NEW MEXICO OIL CONSERVATION DIVISION
- Engineering Bureau -
1220 South St. Francis Drive, Santa Fe, NM 87505

APPLICATION FOR AUTHORIZATION TO INJECT

OPERATOR: Cimarex Energy Co. of Colorado (OGRID 162383)WELL NAME & NUMBER: Thyme APY Federal #11 30-025-36192WELL LOCATION: 1650' FSL & 990' FWL L UNIT LETTER SECTION TOWNSHIP RANGE
FOOTAGE LOCATIONWELLBORE SCHEMATIC

From: Jones, William V., EMNRD
Sent: Monday, October 17, 2011 4:21 PM
To: 'Kay Havenor'
Cc: Ezeanyim, Richard, EMNRD; Gonzales, Elidio L, EMNRD
Subject: Disposal application from Cimarex Energy Co. of Colorado: Thyme APY Federal #11 API 30-025-36192 Delaware 5468 to 6092 feet

Area of Review
1/2 Mile AOR

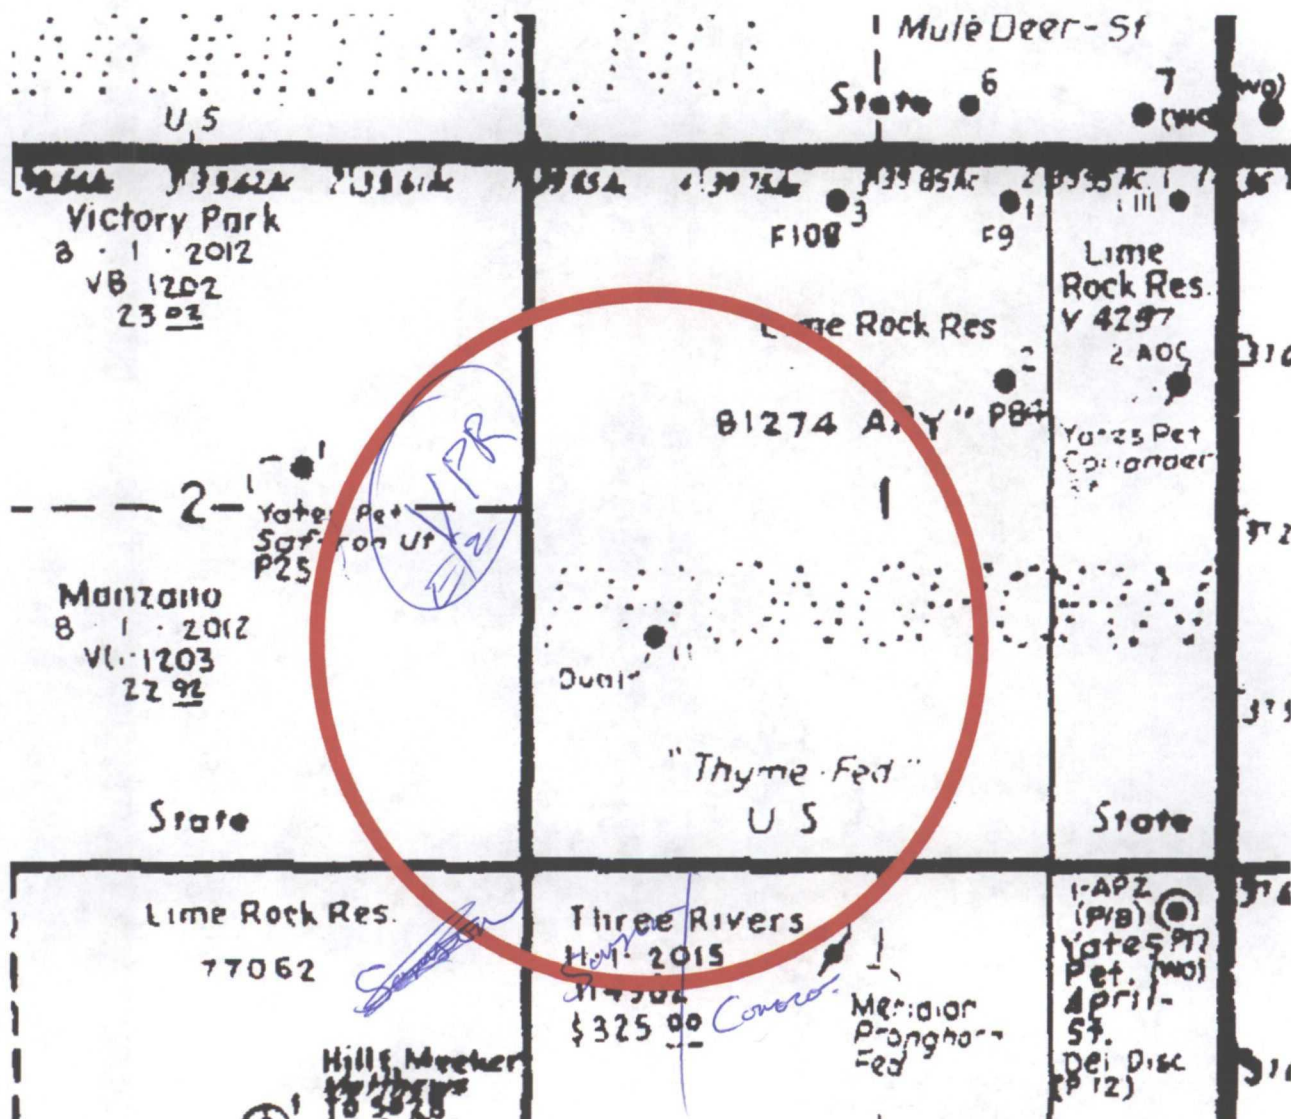
- a. Who owns the Delaware rights in the NE/4 of Section 11 and were they notified? (didn't see that acreage in the notification list)
- b. Who owns those Delaware rights within Section 1 outside the 40 acre spacing unit covered by this well (and inside the AOR)?

Yes sir, Cimarex acquired the NE/4 of Sec 11 also.

- a. Cimarex purchased the Lime Rock Resources leases in and adjacent to AOR - all rights.
- b. Cimarex owns the Delaware rights in Sec. 1 adjacent to the AOR.

Present Configuration of Well

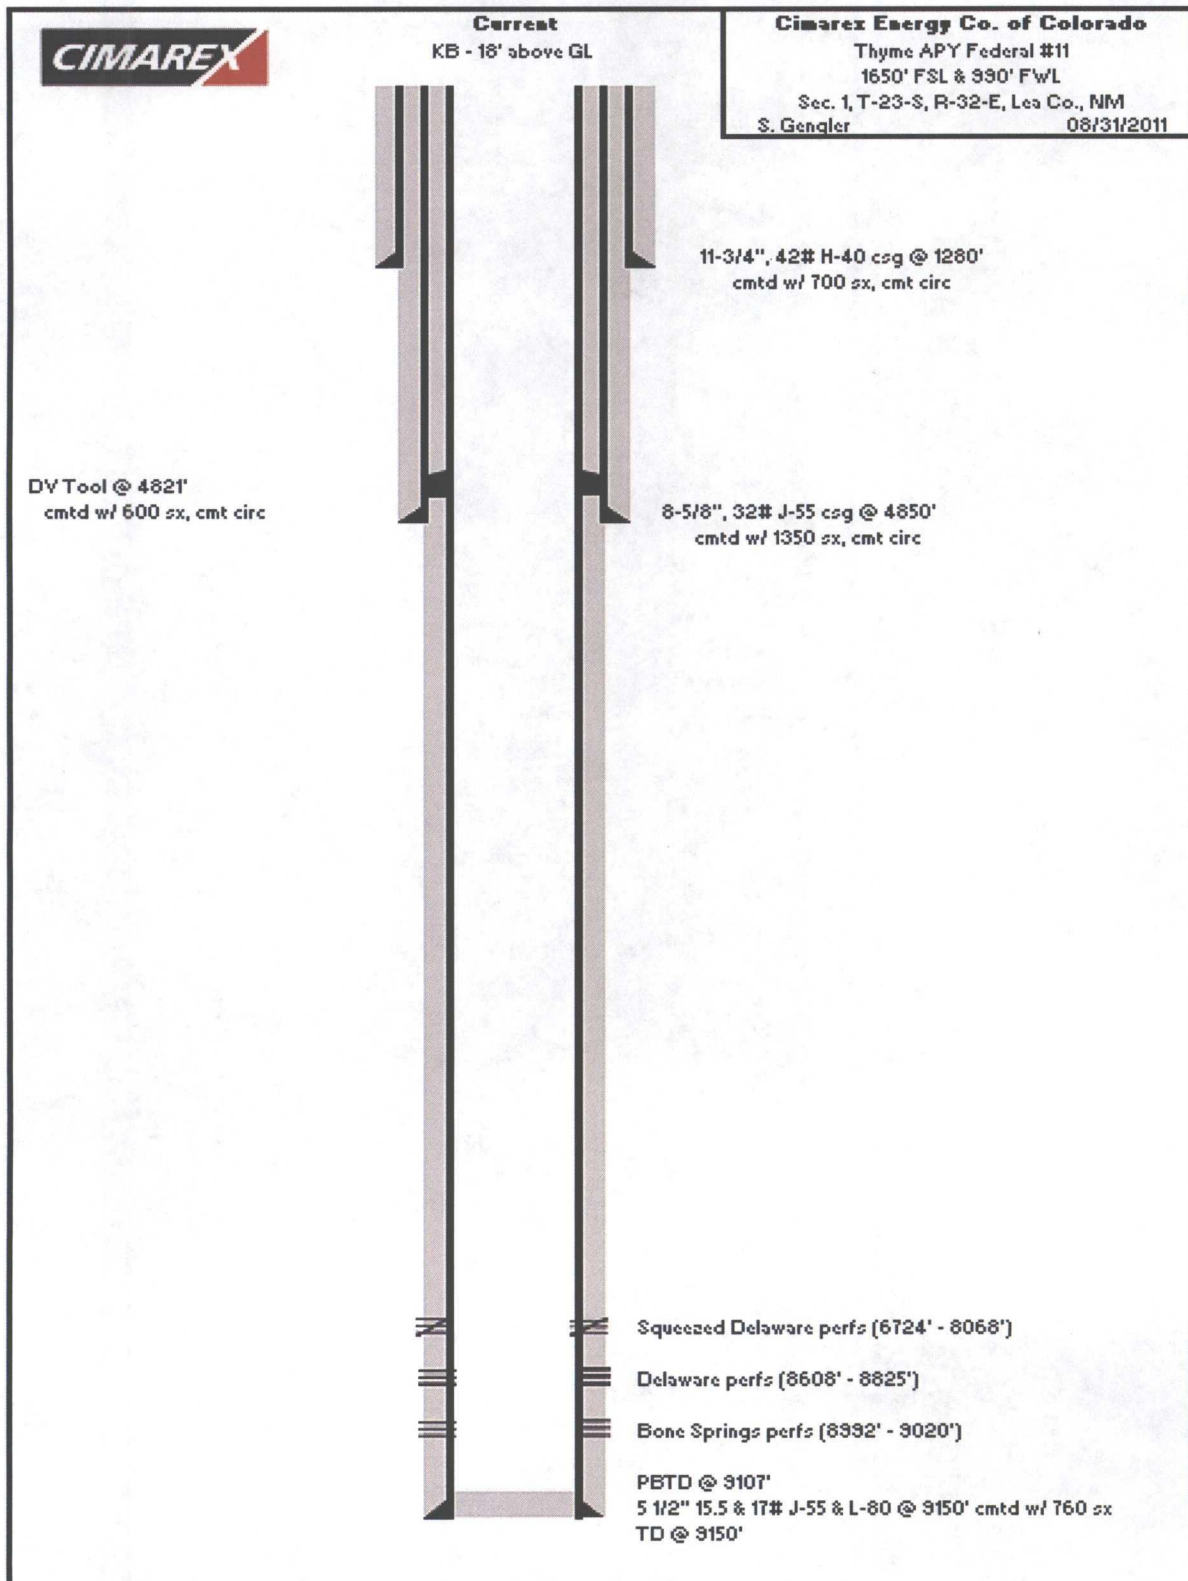
- d. The OCD well file does not have the completion report (that I saw) from the 5-1/2 inch showing casing, cement, DV, etc. Since this is a federal well we may have missed it. Would you ask Cimarex to find their internal records of this casing/cement job and send to the OCD office in Hobbs? The intended DV tool depth in our files shows 8800 feet, but your report shows much shallower.

- e. Please send a copy of the CBL to Hobbs for scanning.
- f. Due to the possible micro annulus as per the Halliburton report, the disposal permit may require an injection tracer/temp survey to verify disposed waters stay in the permitted interval – if not, some remedial work would need to be done. Please send any comments?

- c. Cimarex Energy Company of Colorado does/will operate the well and will operate the SWD.
- d. You are correct in that Yates (original operator) did not supply cement data and DV info for the record. The DV tool depth of 8000' is in Yates' APD and shown as page 5 in the OCD online. Yates' BLM completion 3160-4 (OCD online image page 20) reports 5-1/2" 15.5# & 17# was run from surface to TD 9,150' cemented to surface with 1360 sx cmt, but does not report DV tool depth. Cimarex's well diagram dated June 8, 2011, in the well file (page 37), shows DV tool at 4,821' and TOC for 5-1/2" at 5,500'. That reported TOC 5,500' in the Cimarex diagram was in conflict with Yates' reported data. I requested clarification. Cimarex engineers examined my query and opp-ed further confirmation by the Midland Halliburton cement log expert. I incorporated Halliburton's response along with a revised "Present Configuration of Well" diagram prepared by Cimarex into the submitted C-108. I have today requested Cimarex examine original (Yates) data, if any, to obtain details on cement and that cement job.

e. Cimarex has been requested to submit a copy of the Thyme APY #11 CBL to Hobbs.
f. I am confident Cimarex will comply with any injection survey requirements included in a SWD permit. They are anxious to handle their produced water.
Please let me know if the above adequately responds to your concerns. Thank you for the opportunity to respond.

As follow-up to my previous email: attached is a copy of the original Yates casing report on their 5-1/2" string with all cementing data. Fundamentally, it confirms the DV tool was set at 4821' and second stage circulated. Cimarex also sent me a digital copy of the CBL that Halliburton reviewed. I am arranging for that to go to Patricia Martinez in Hobbs. Let me know if you wish to view the digital log. Thank you.
